Comment on Project Funding.

Comment on Installed Capacity (ISH2 overplanting ratio).

Final Audit Report (Adobe Acrobat Sign)

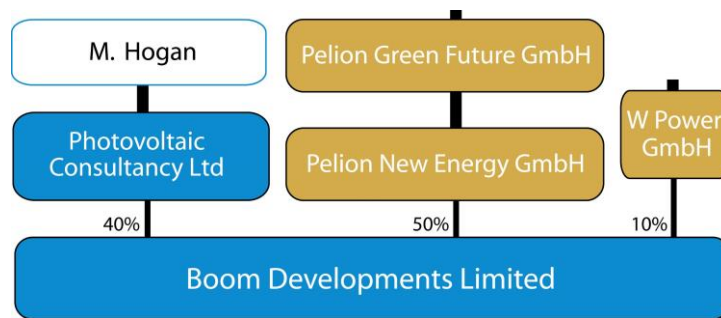
This item may have been appended in error. The only additional evidence it contributes is to demonstrate that Herr Krüger is a spectacularly fast worker: he can open an email, review and approve a multi-million-pound Letter of Support (in a foreign language), e-sign it (twice) and send it off by email with a signature request – all in just 13 seconds (7:03:55 to 7:04:08). English is my first language, and I barely make it to the end of the first paragraph in 13 seconds.

The cosine relationship (GCSE Physics revision)

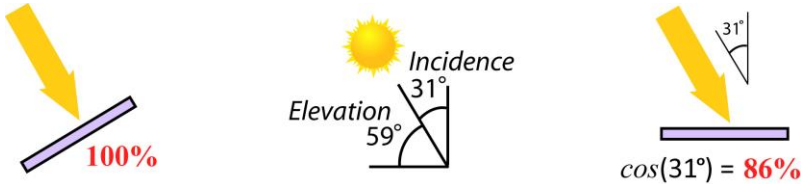
Unfortunately, the Applicant still fails to appreciate that when the PV panel does not face the sun directly (as is the case for SAT), you have to factor in the angle of incidence (see box). In our case the angle is 31°, so the Installed Capacity must be increased to 560 MW:

In Yorkshire, a panel that faces the sun directly (e.g. FSF) generates the rated output (**100%**). But, if the light strikes the panel at an angle (e.g. SAT), the irradiance power received by the panel is reduced depending on the cosine of the incidence angle. Maximum sun elevation is 59°, so the angle of incidence is 31° (90° – 59° = 31°). Thus the peak output power is scaled by $\cos(31^\circ)$, which gives approximately **86%** of the panel's rated output.
